FLOOD DESIGN REPORT

A2I | Albury to Illabo

Package: A2I – Uranquinty Yard

5-0052-210-IHY-W1-RP-0001

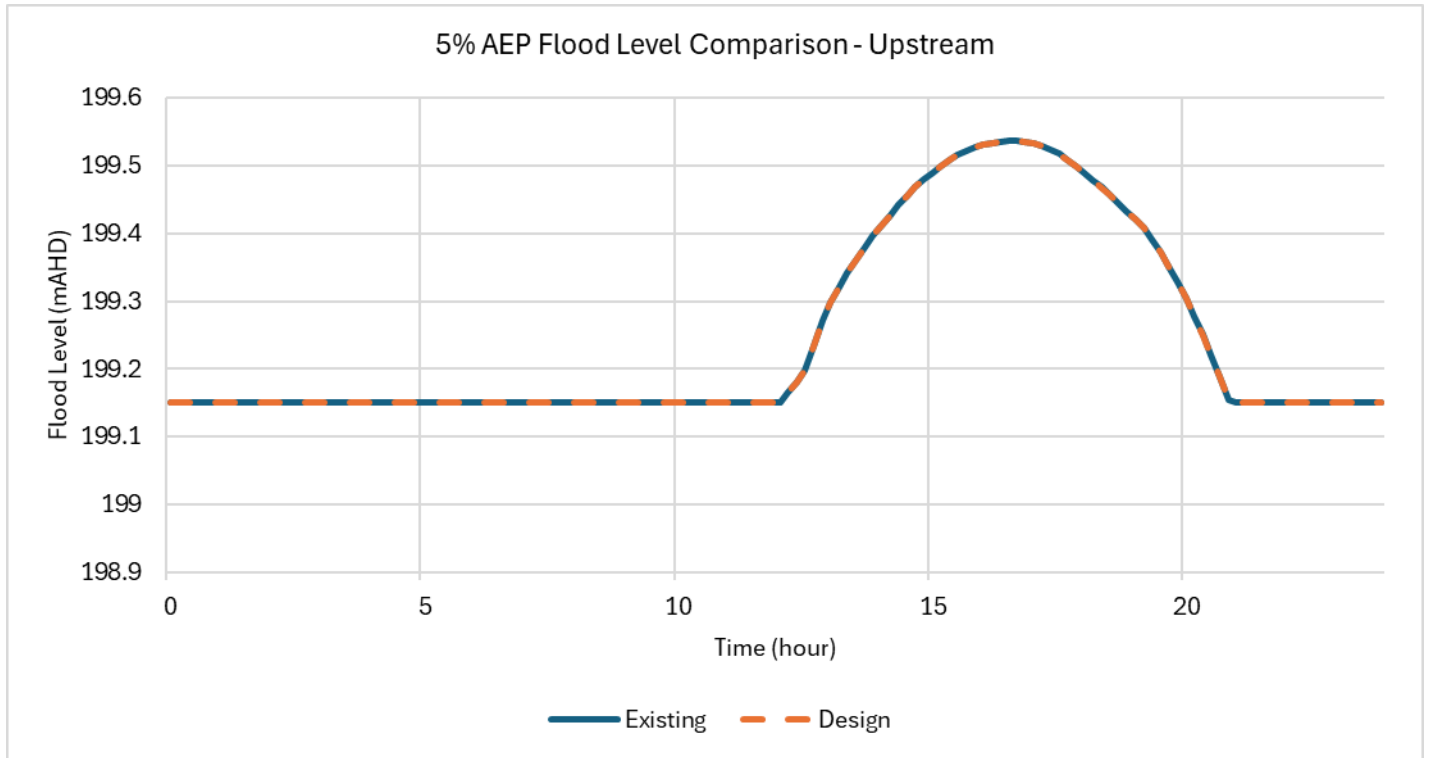
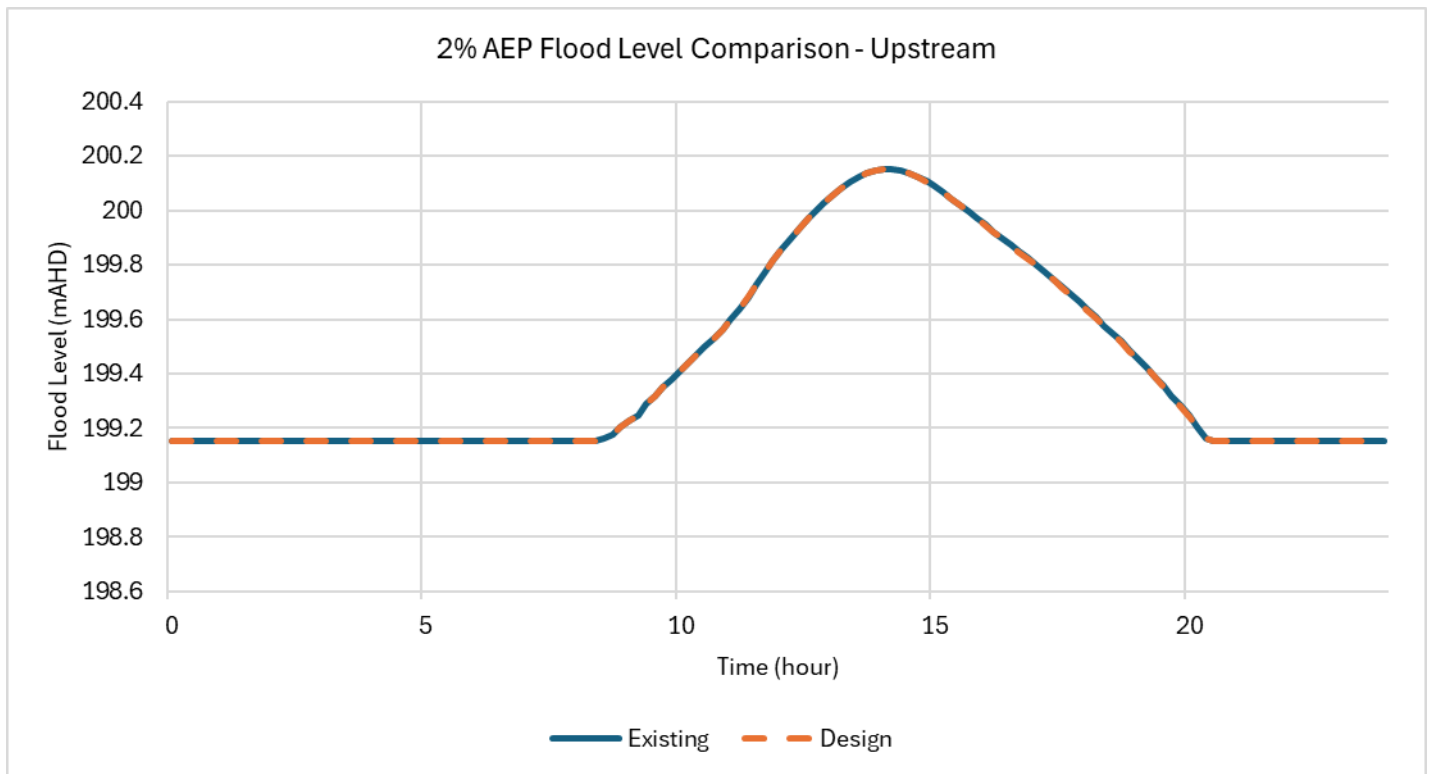
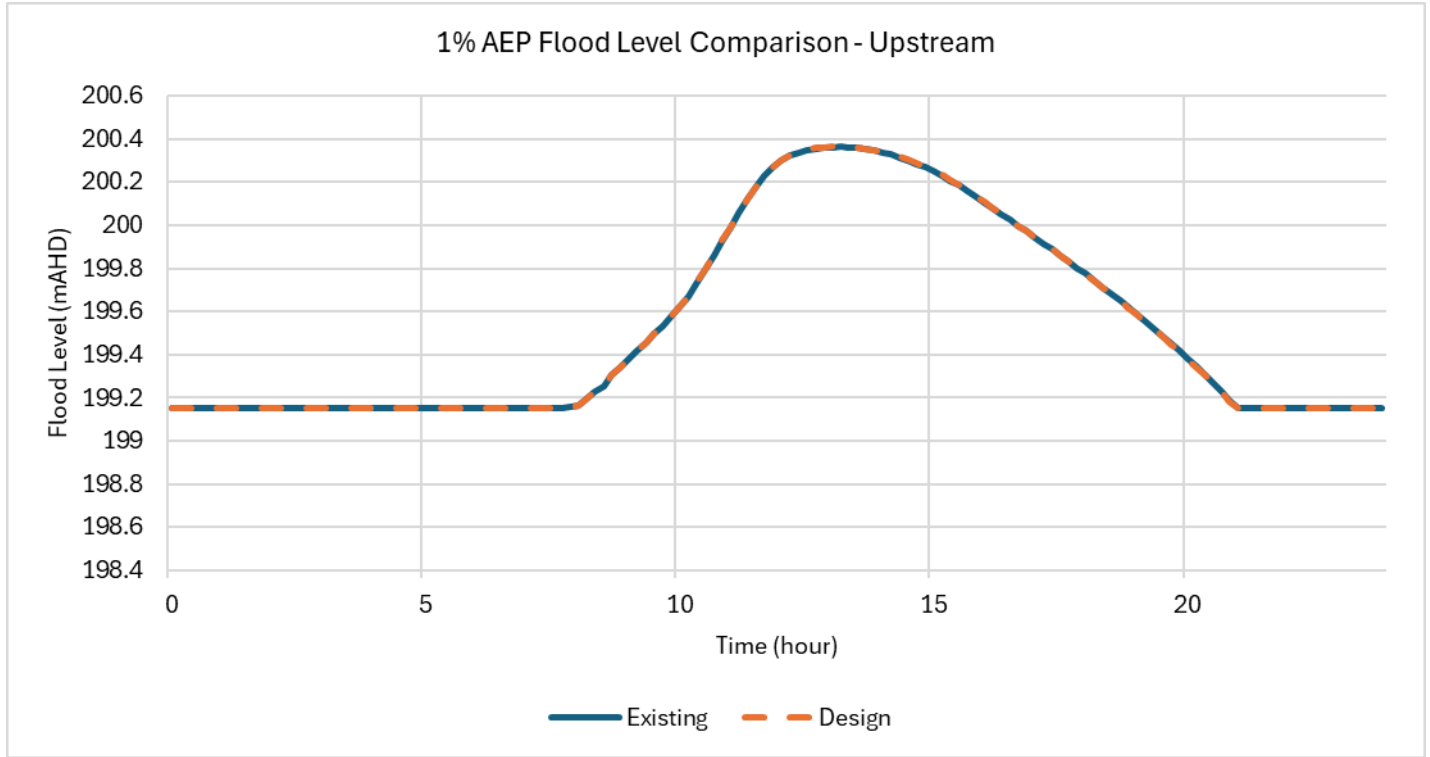
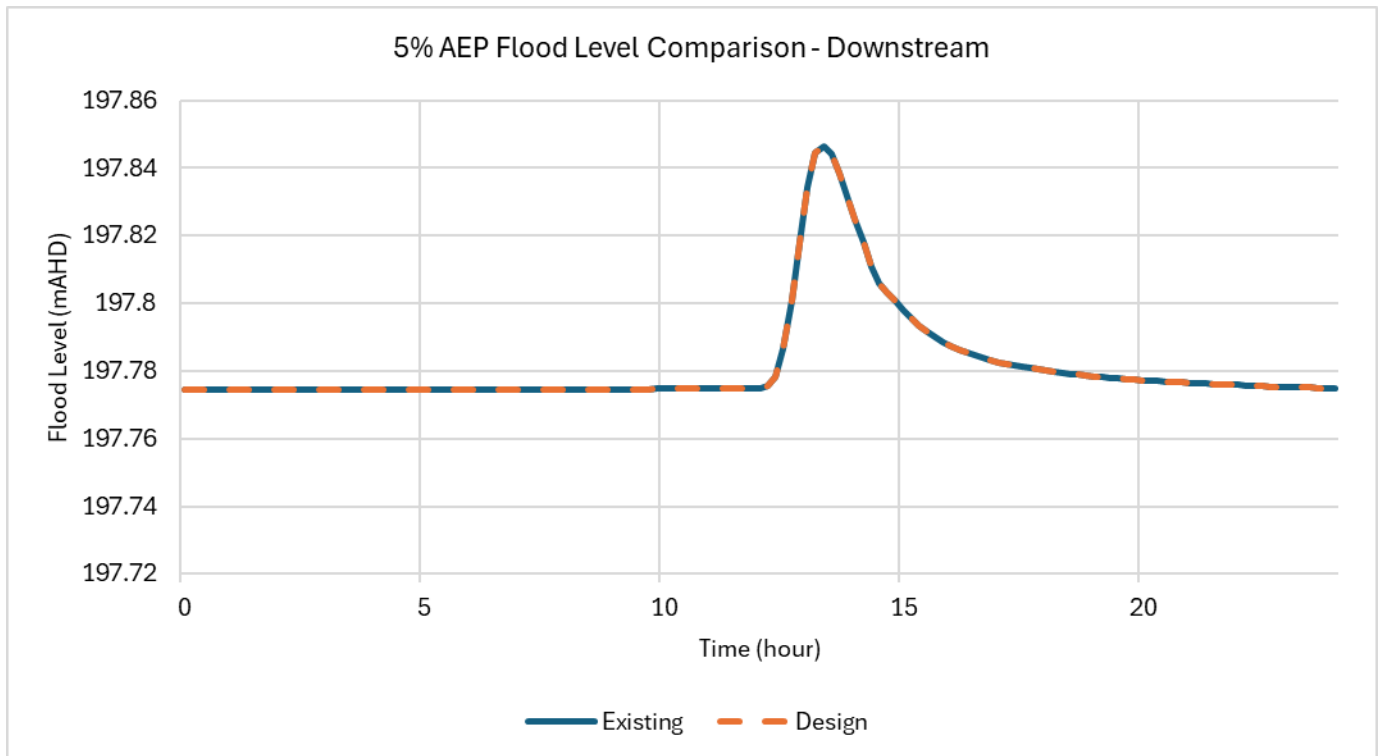
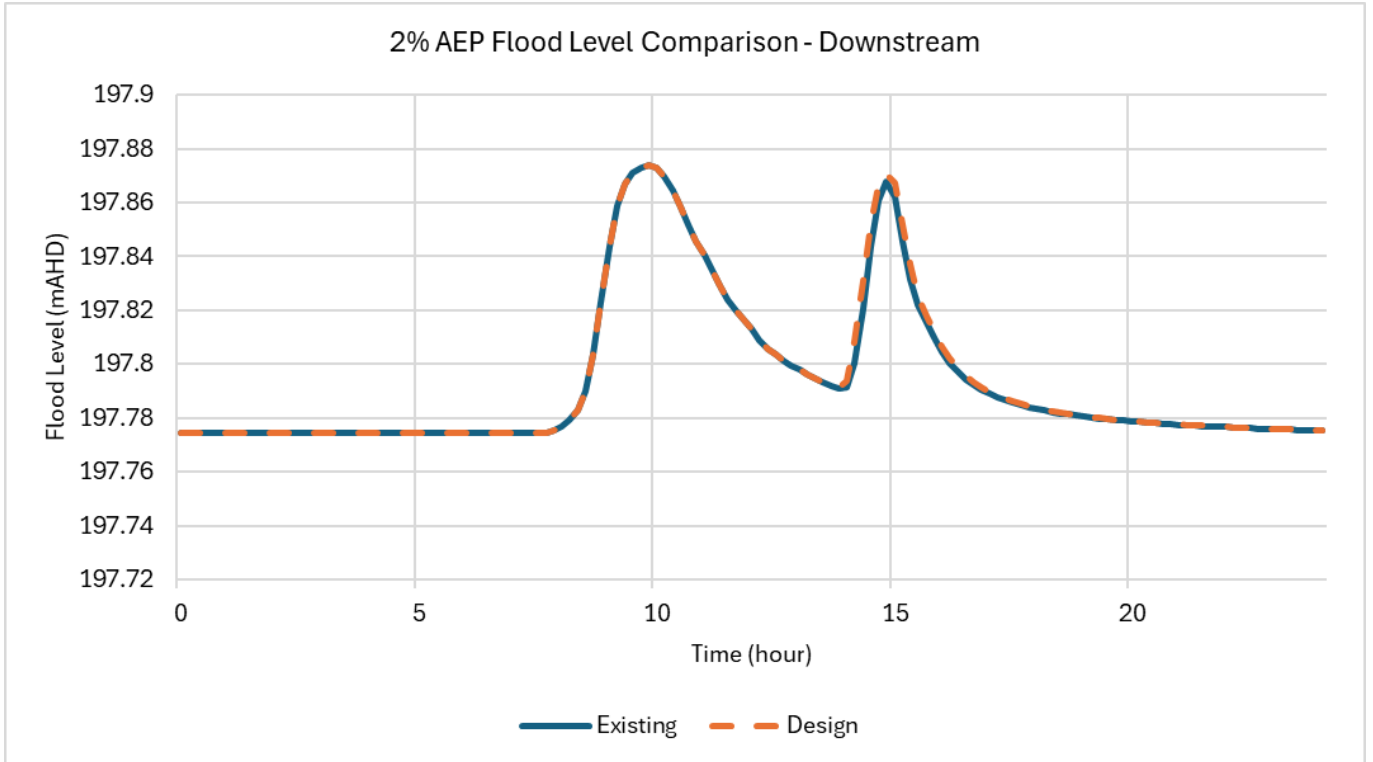
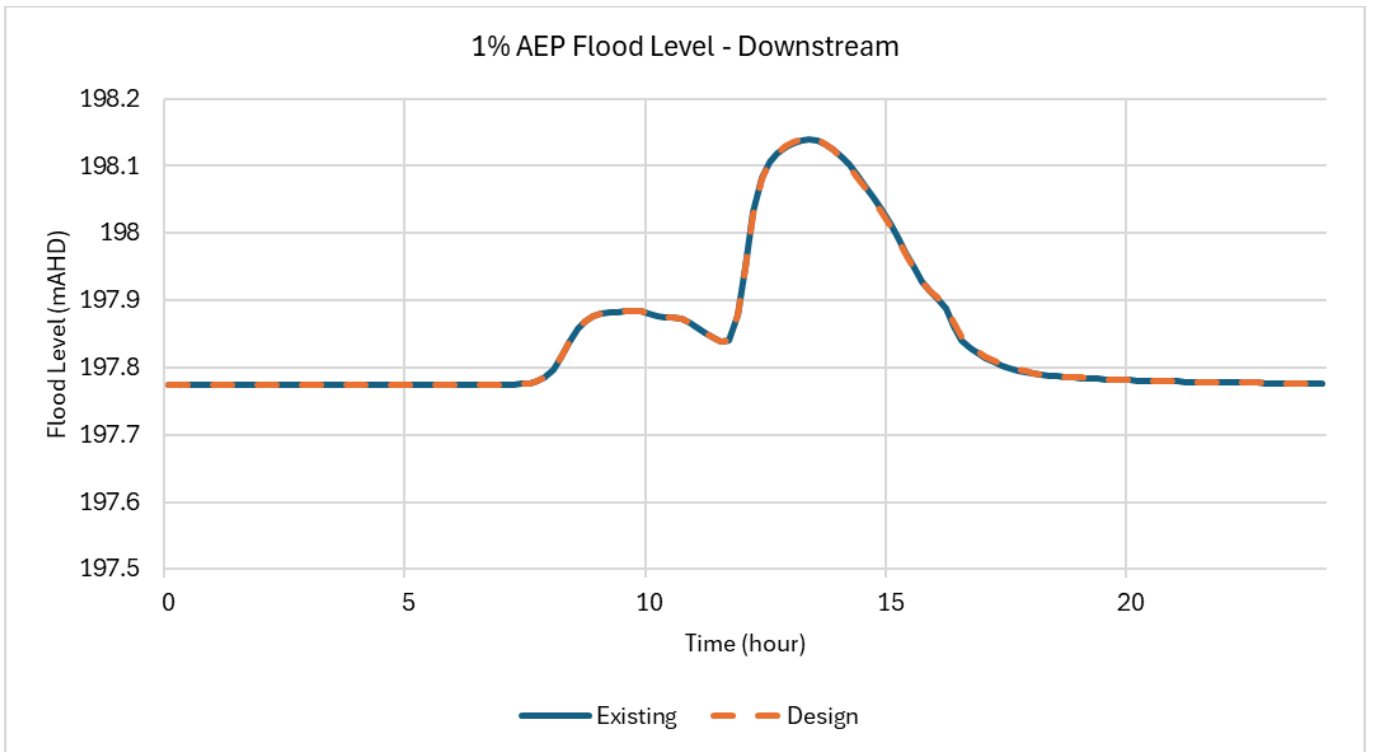
9	Clarification	5-0052-210-IHY-W1-RP-0001_B.pdf	Page 42, 5-0052-210-IHY-W1-RP-0001_B, Figures 6-11 to 6-16	DDR	The term "Level vs Time" should be replaced with "Flood level vs Time" for better clarity	Opportunity	Ayub Ali	14/03/2025	Yucen Lu	DJV Flood Modeller	28/04/2025	Updated the words. The snips are attached below.		Ayub Ali	2/06/2025	CLOSED	This item is closed based on the response and its screenshot evidence.
